Final Subsequent Environmental Impact Report

Sunshine Canyon Landfill

State Clearinghouse Number 92041053

EXECUTIVE SUMMARY
FINAL SUBSEQUENT ENVIRONMENTAL IMPACT REPORT
SUNSHINE CANYON LANDFILL
SEIR 91-0377-ZC/GPA
State Clearinghouse Number 92041053

FIGURE NO.	2.7-3a (REVISED)
PROJECT NO.	HL0178-62-1
DATE:	6 MAY 1998

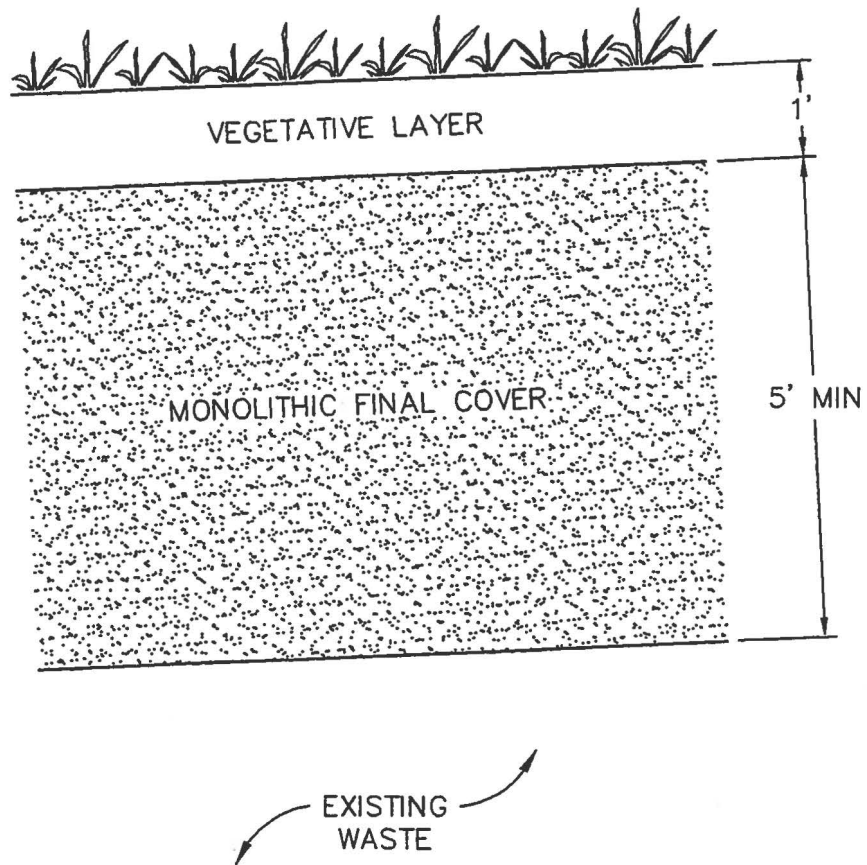
Section 2.7.4, Leachate Collection and Removal System, Figure 2.7-3, p. 2-59

Figure 2.7-3 (Preferred Waste-on-Waste Liner) has been revised as Figures 2.7-3a (Monolithic Cover for Sunshine Canyon City Landfill Closure) and 2.7-3b (Preferred Waste-on-Waste Liner and Re-compacted Monolithic Final Cover) to reflect the proposed monolithic final cover and the waste-on-waste liner.

FIGURE NO. 2.7-3B (REVISED)

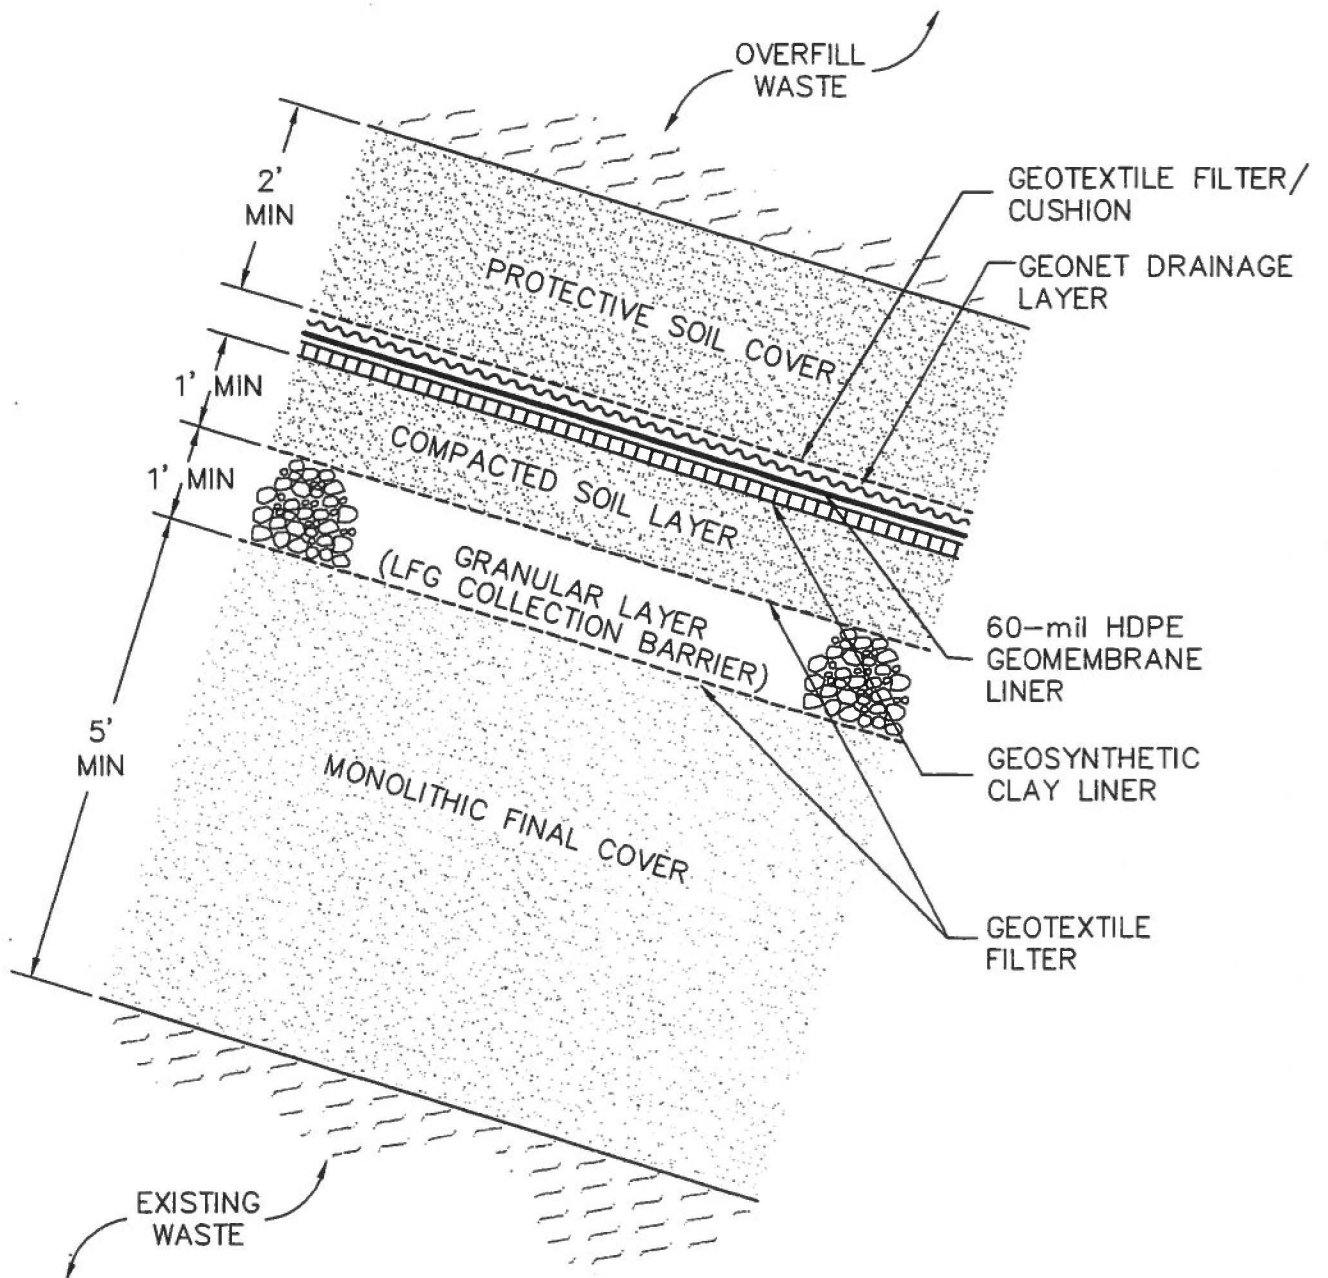
NOTE: ENGINEERING DETAIL OF WASTE ON WASTE LINER
REVISED FOR JOINT TECHNICAL DOCUMENT

FIGURE NO. **4.1-1 (REVISED)**
PROJECT NO. HL0178-62-1
DATE: 15 JUNE 1998

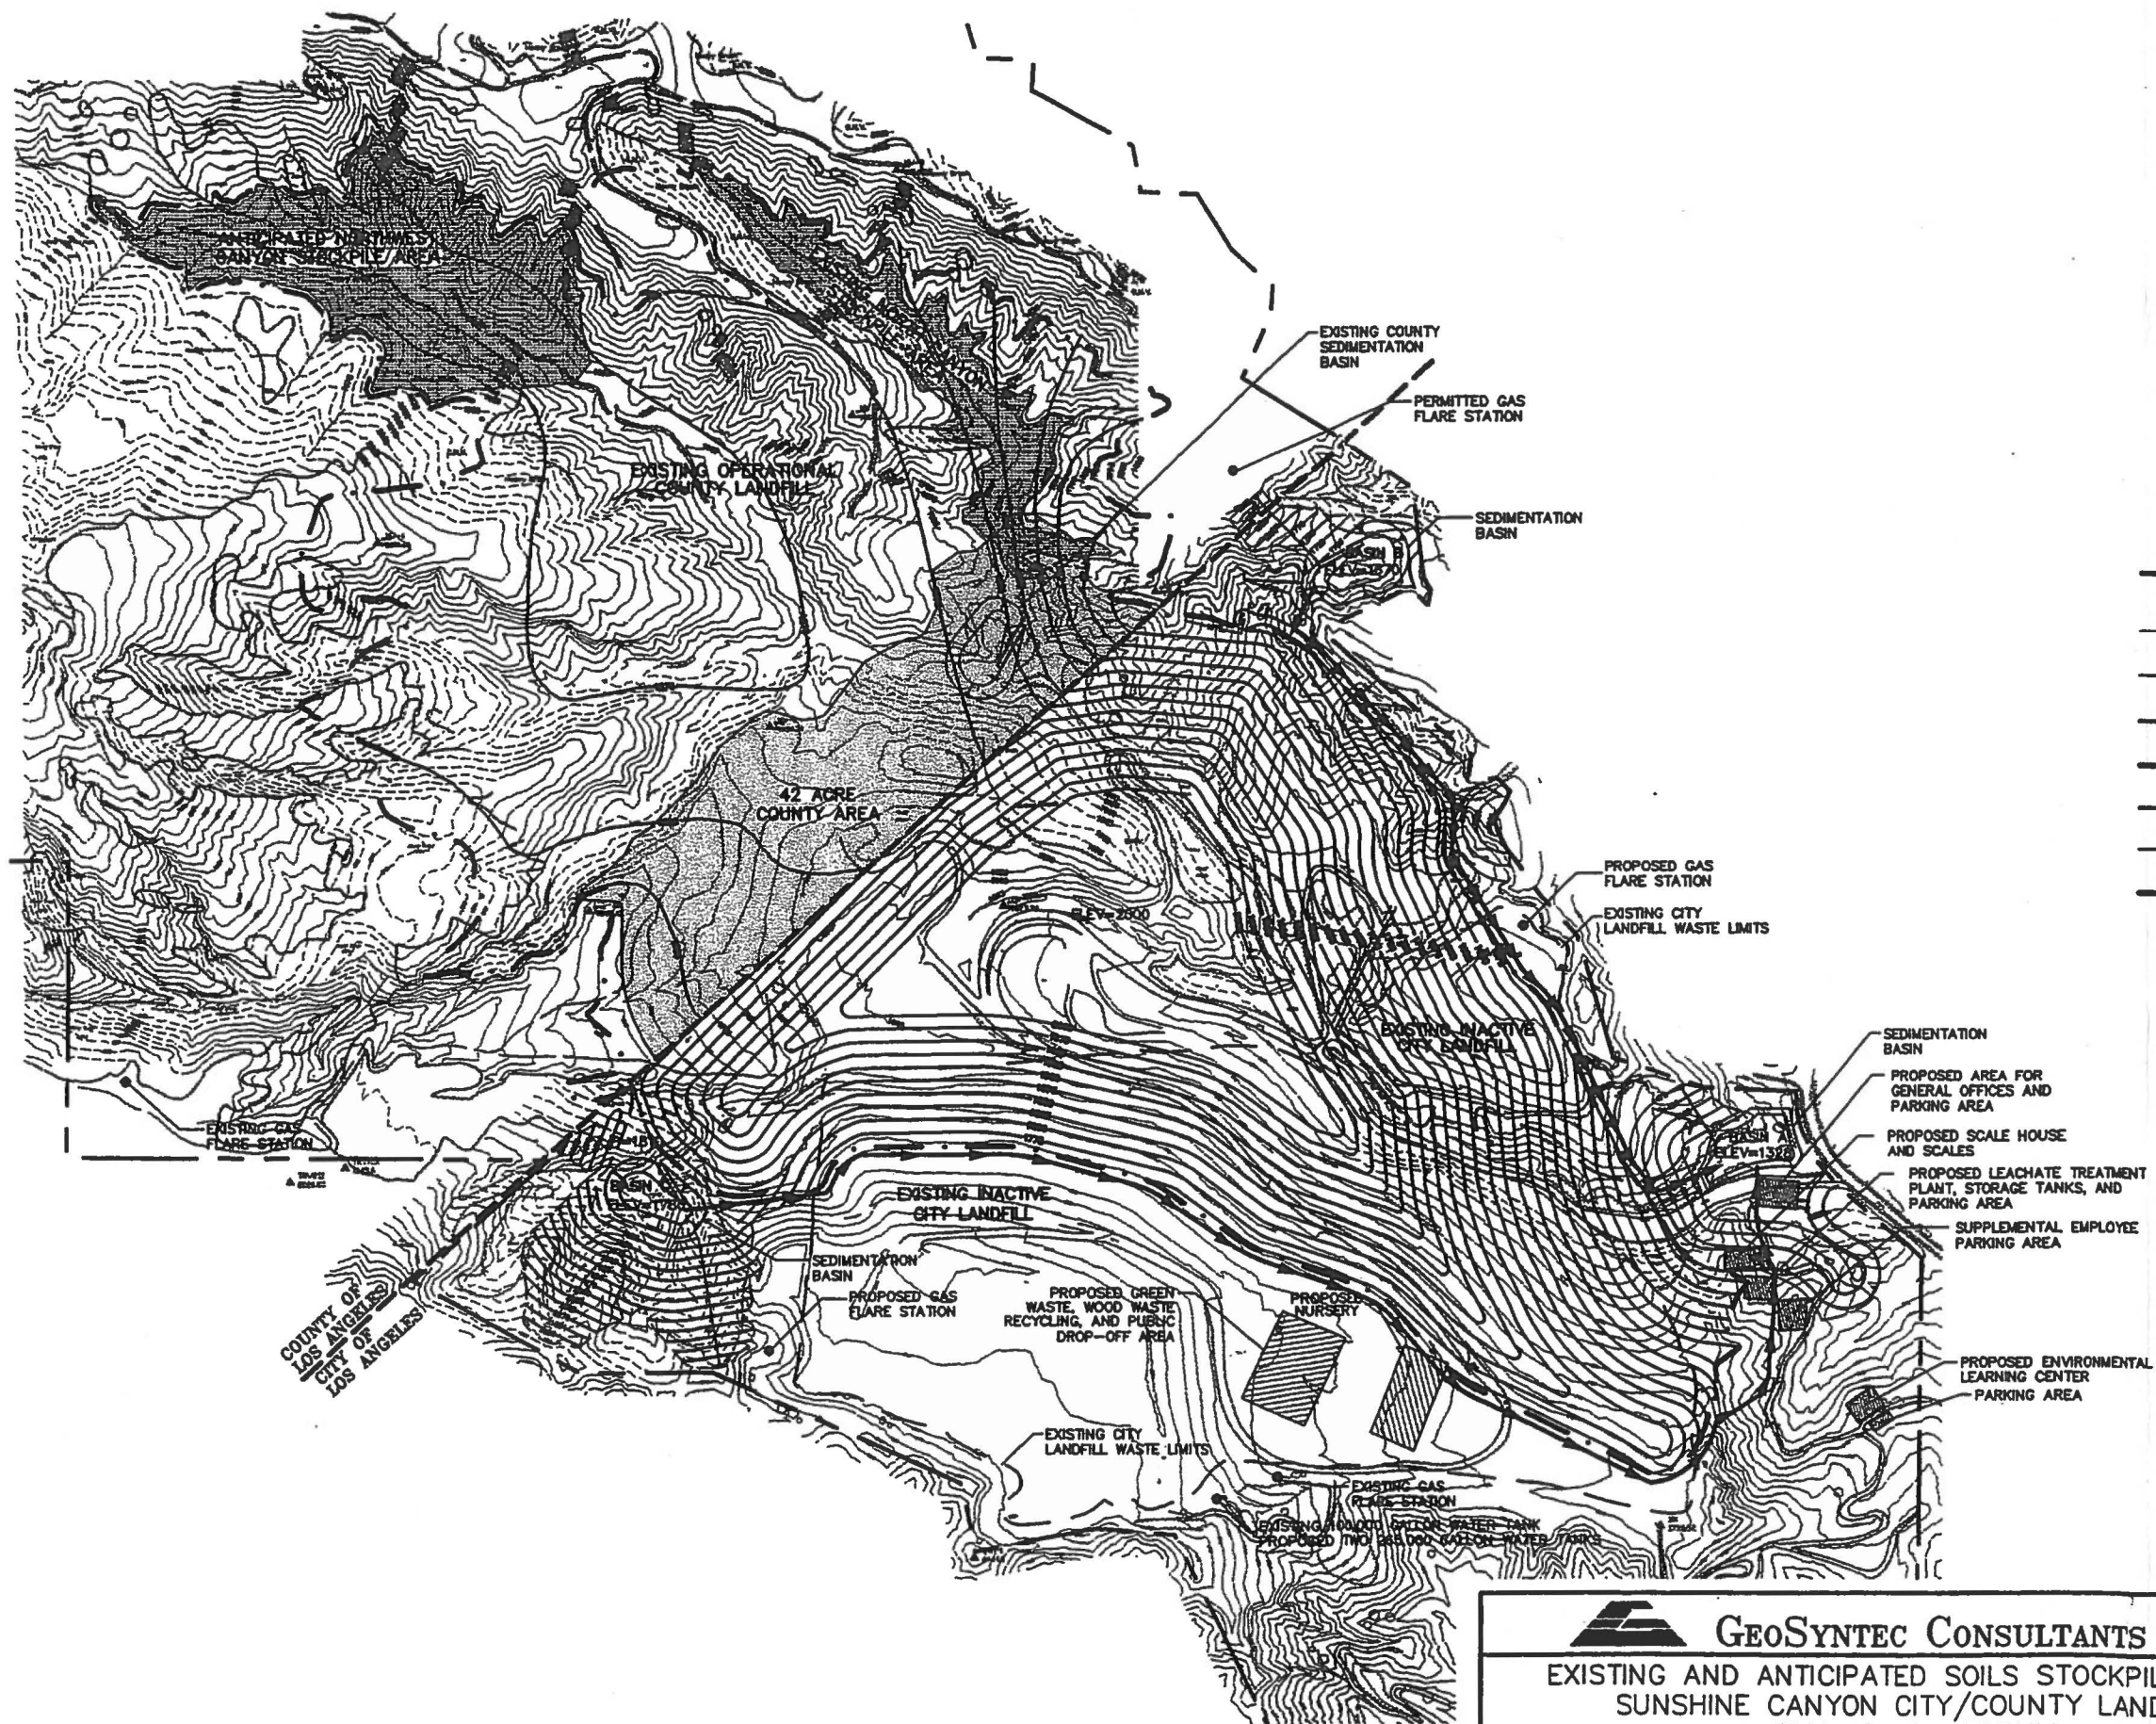
Section 4.1.1, Grading Activities, Figure 4.1-1, p. 4-5

This figure has been revised to delete the previously proposed stockpile area on the top deck of the existing inactive City Landfill.

FIGURE NO. **5.5-1 (REVISED)**

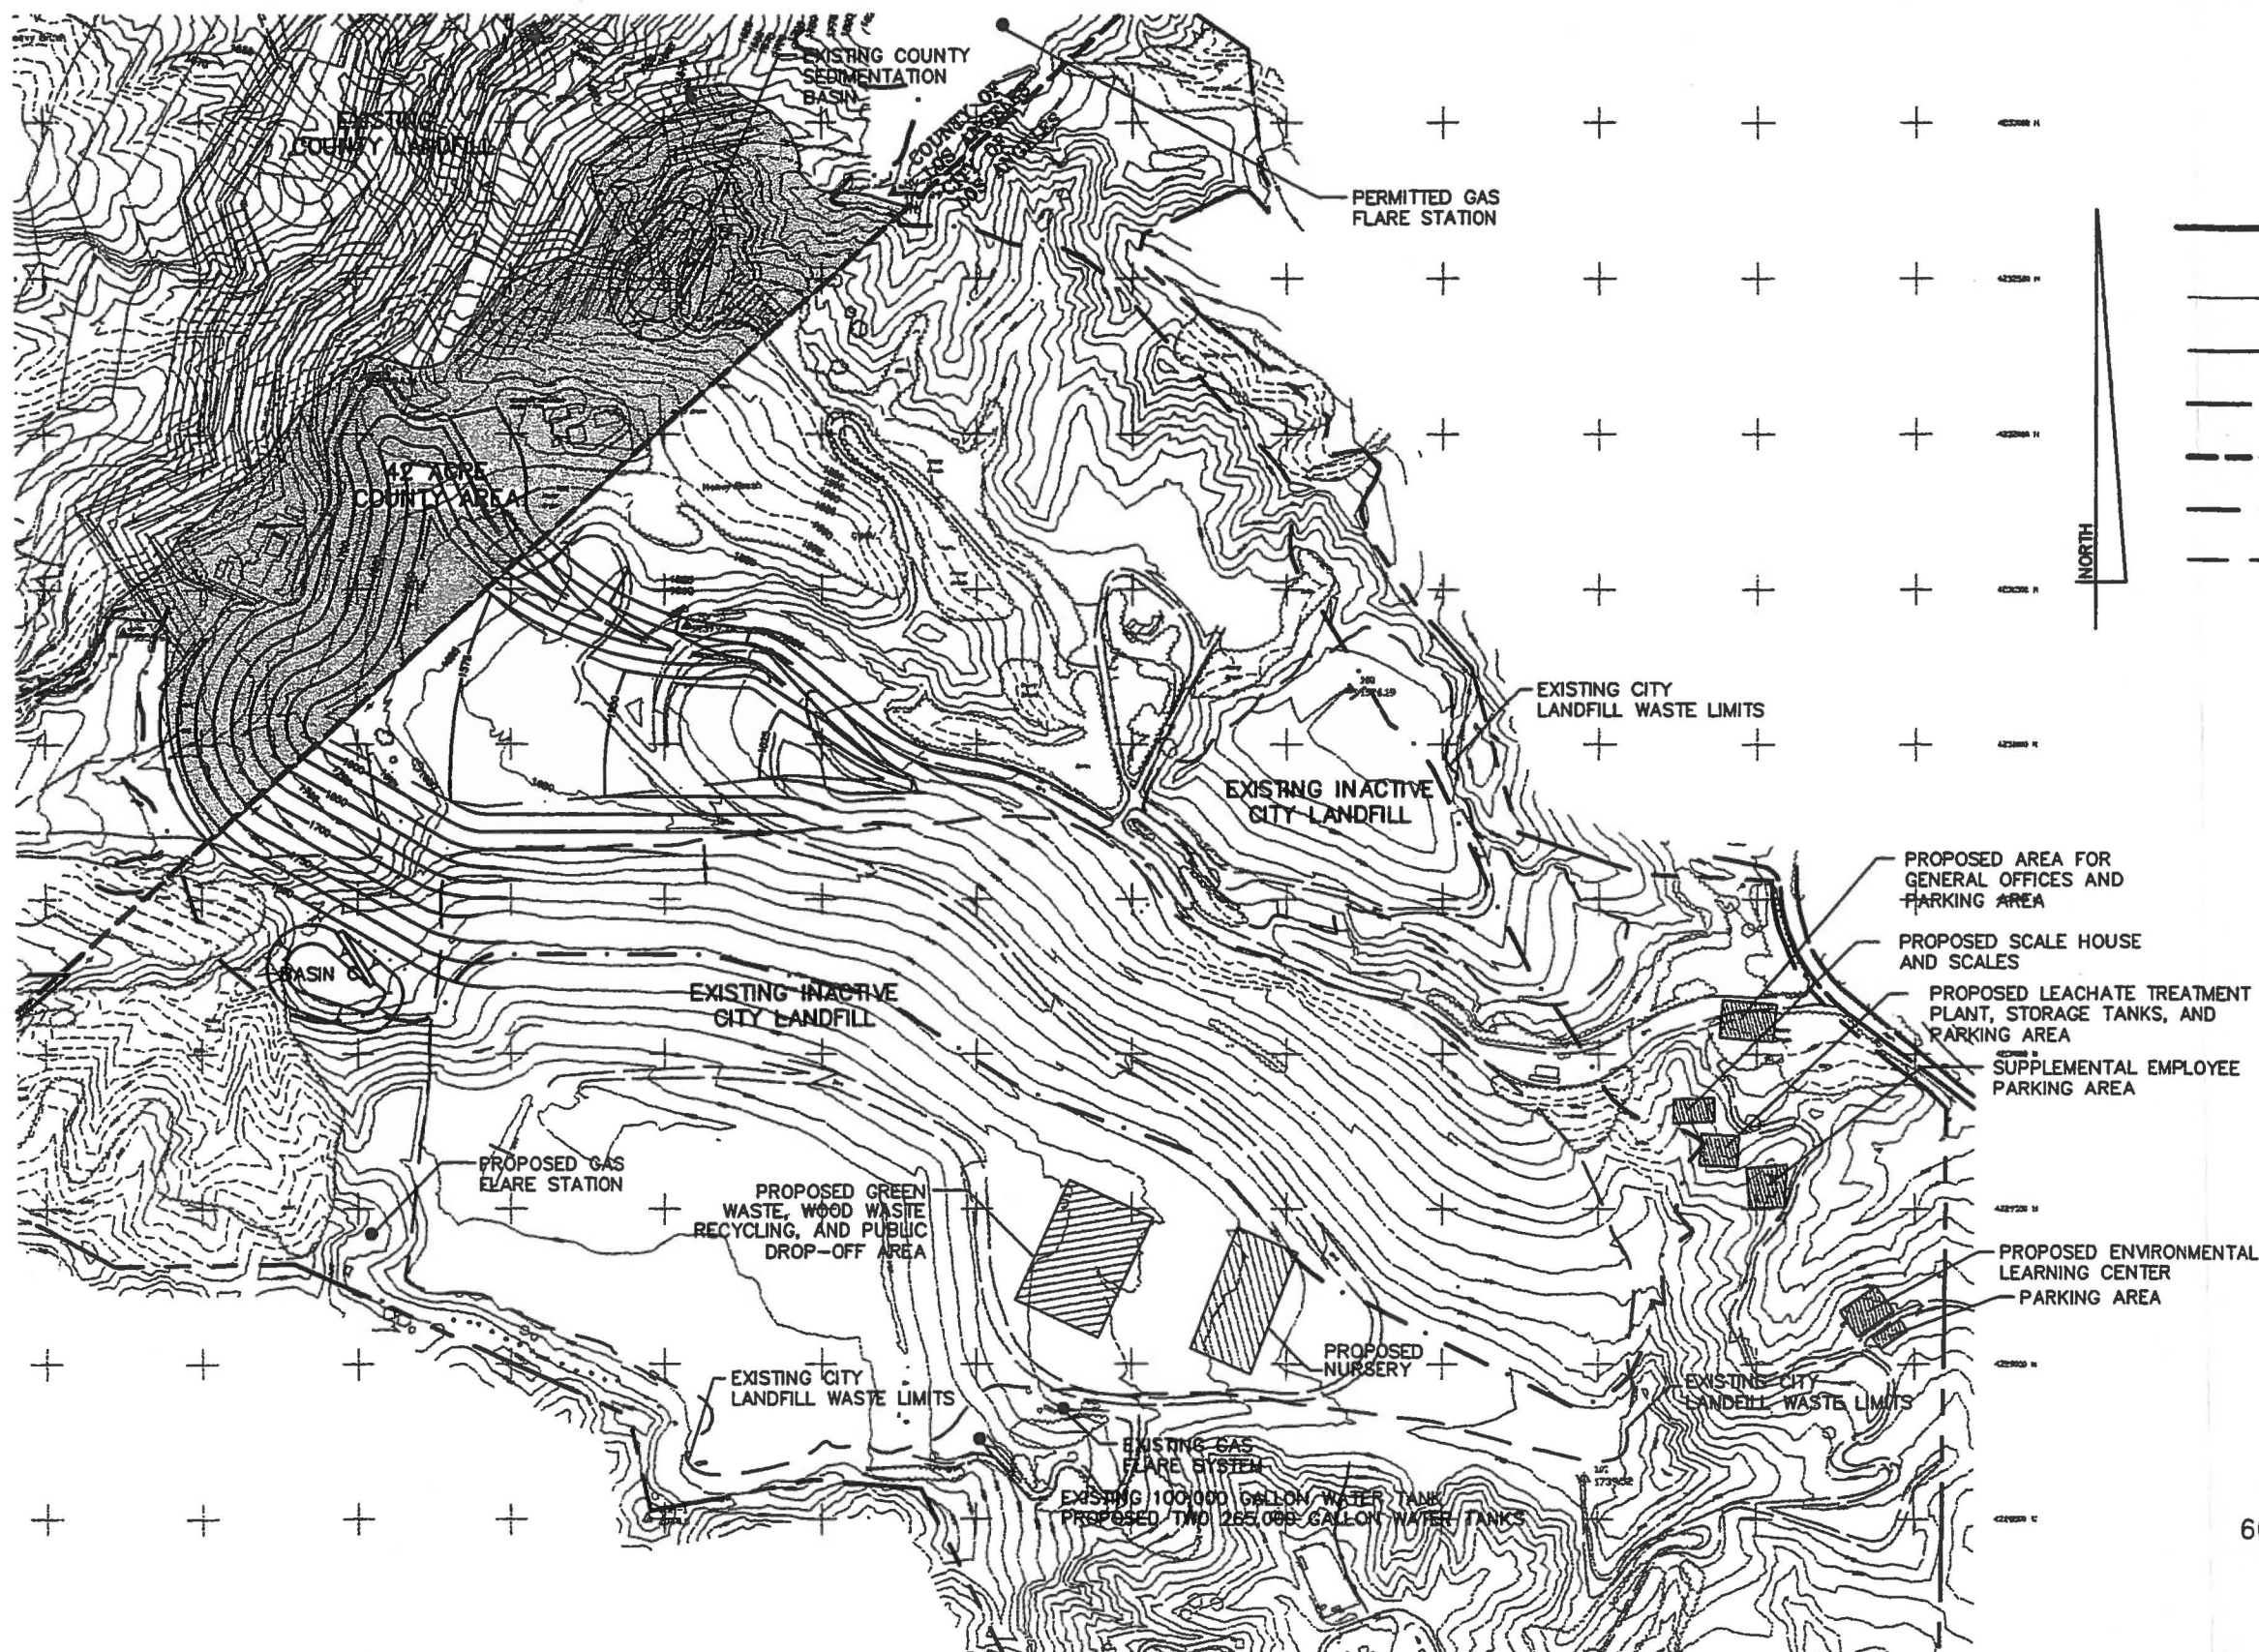
Section 5.5, Reduced Volume Alternative, Figure 5.5-1, p. 13

These changes, made by the project proponent, are not in response to any of the comments included in Section 3.0 of this document.
